The Commission has issued the enclosed Amendment No. 88 to Facility Operating License No. DPR-31 and Amendment No. 82 to Facility Operating License No. DPR-41 for the Turkey Point Plant Unit Nos. 3 and 4, respectively. The amendments consist of changes to the Technical Specifications in response to your application transmitted by letter dated April 15, 1982.

These amendments change the Technical Specifications to modify FQ and Figure 3.2-3, K(Z) versus core height, for the repaired steam generators.

AMENDMENT NO. 88 TO FACILITY OPERATING LICENSE NO. DPR-31

AMENDMENT NO. 82 TO FACILITY OPERATING LICENSE NO. DPR-41

FIG. 3.2-3a

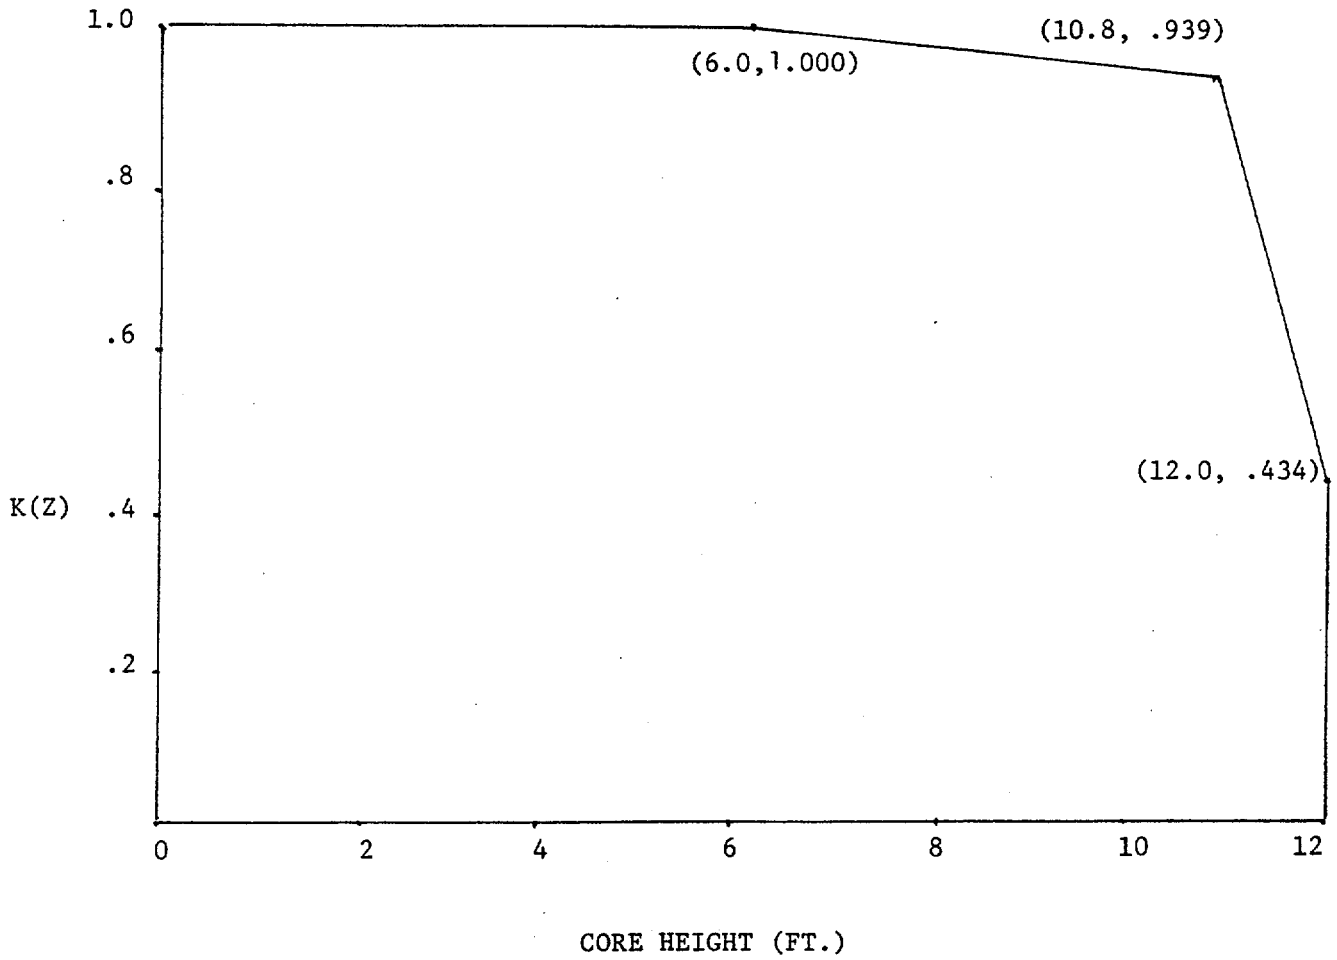
Where P is the fraction of rated power at which the core is operating; K(Z) is the function given in Figure 3.2-3 or Figure 3.2-3a; Z is the core height location of F_Q . $[F_Q]_L$ and K(Z) are dependent on the steam generator tube plugging level as follows:

Plugging level	$[F_Q]_L$	Figure Number for K(Z)
>5 % and \leq 28%	2.125	3.2-3*
\leq 5%	2.30	3.2-3a

* The F_Q of 2.125 and Figure 3.2-3 do not apply to future degradation of the new steam generators.

HOT CHANNEL FACTOR
NORMALIZED OPERATING ENVELOPE

(for $\leq 5\%$ steam generator tube plugging and $F_q = 2.30$)

FIGURE 1. Variation of peak clad temperature with discharge coefficient for Turkey Point Units 3 and 4.

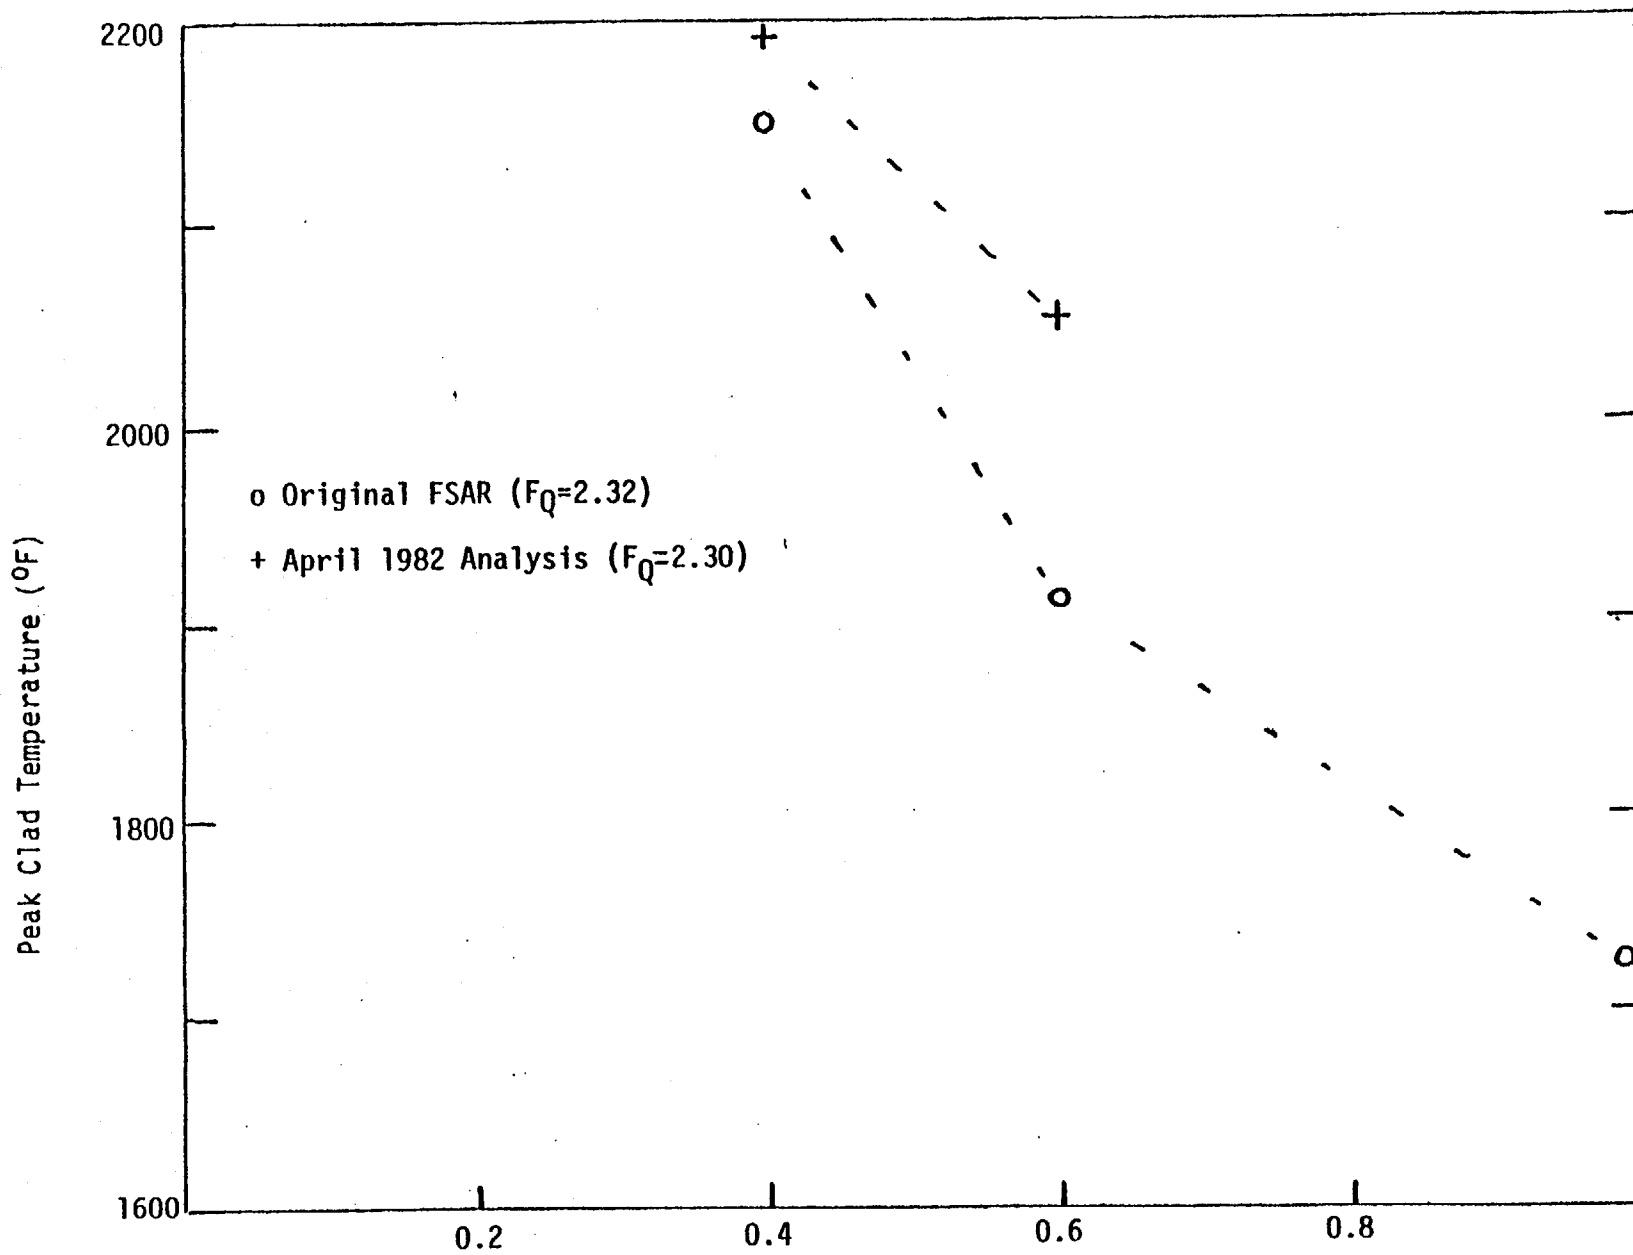
The latest analysis also covers only the DECLG with C_D equal to 0.4 and 0.6. Although the replacement of the steam generators return the plants to the condition analyzed in the original FSAR, there are some differences in the new analysis. Most importantly, the model codes have changed considerably to account for better understanding of clad swelling and rupture, two phase flow and other phenomena. Nevertheless, the new calculations for F_Q equal to 2.30 predict compliance with the acceptance criteria of 10 CFR 50.46. Furthermore, the dependence of peak clad temperature on the choice of C_D (Figure 1) leads to the conclusion that the DECLG with C_D equal to 0.4 is still the worst case LOCA.

Reanalysis of the large break LOCA with the latest approved Westinghouse model (1981 model) has reinforced the original finding that the DECLG with C_D equal to 0.4 is the worst case LOCA. The calculated values of peak clad temperature, maximum clad oxidation and minimum hydrogen generation are within the acceptance criteria of 10 CFR 50.46 for operation at F_Q equal to 2.30 and tube plugging $\leq 5\%$.
